#### SUMMARY OF COMMENTS AND RESPONSES

1661 PINE STREET
RESIDENTIAL LIFE CARE FACILITY
DRAFT ENVIRONMENTAL IMPACT REPORT

October 1992

89.037E

1661 Pine Street Franklin Street Looking North

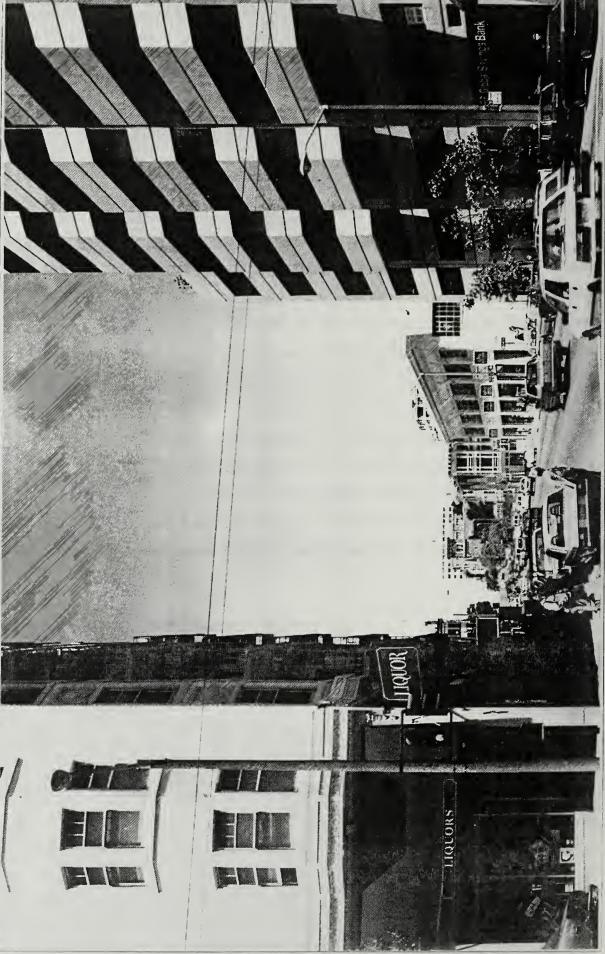
- One set of photographs is used to illustrate existing views of the site, and a different set of photographs is used [to] simulate the visibility of the project upon completion. The same views, if not the identical photographs, should be used to depict the site's aesthetic setting and for montages to be prepared. Otherwise, the conditions "before" and effects "after" development cannot be compared, thus negating the purpose and undermining the fairness of the analysis.
- Figure 16 shows the project looking east on Pine and suggests that land uses and building heights are uniformly greater and higher east of the site. Without pairing Figure 16 with a montage of the site photographed from a viewpoint on lower Nob Hill looking west,

The DEIR provides existing site photos in the Setting Section and photomontages of the proposed project in the Impacts Section. The photomontage setting photos were not included in the DEIR but are shown on pages C&R.89 through C&R.93 as Figures C&R-1 through C&R-5. The photomontages are a representative sample of the proposed project. Montages cannot be prepared for all directions. Figure 20 provides one perspective of the project in relation to the adjacent neighborhood on both sides of Van Ness Avenue.

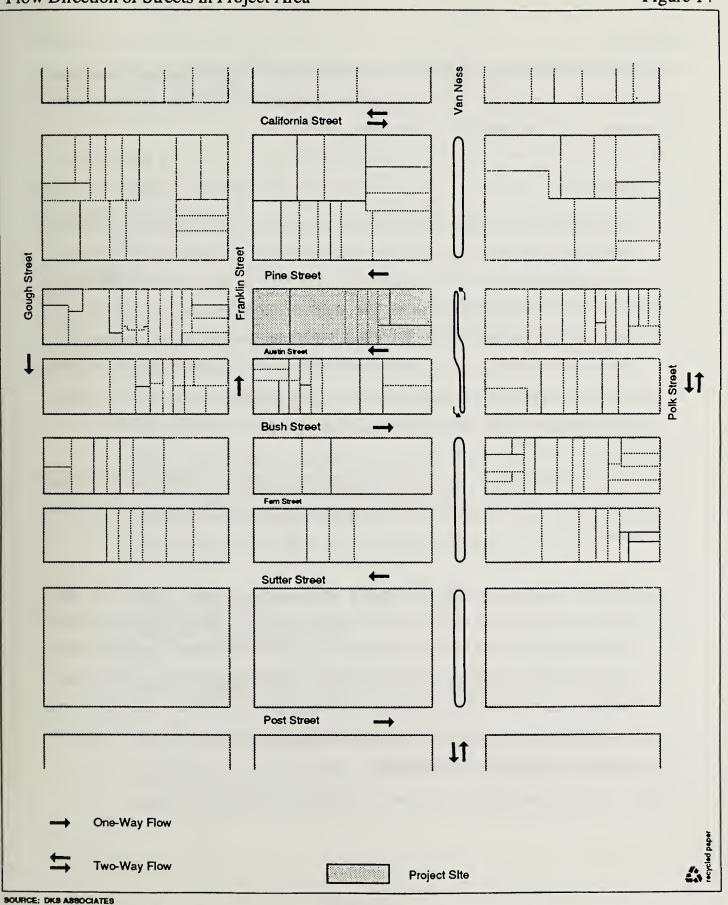
"(Page 56). Map should show where turns are permitted and barrier island down Van Ness, including turn pocket." (Sue Hestor, Attorney)

Figure 14, page 56 of the DEIR and page C&R.121 of this document, has been revised to show where turns are permitted and the placement of the barrier island on Van Ness Avenue.
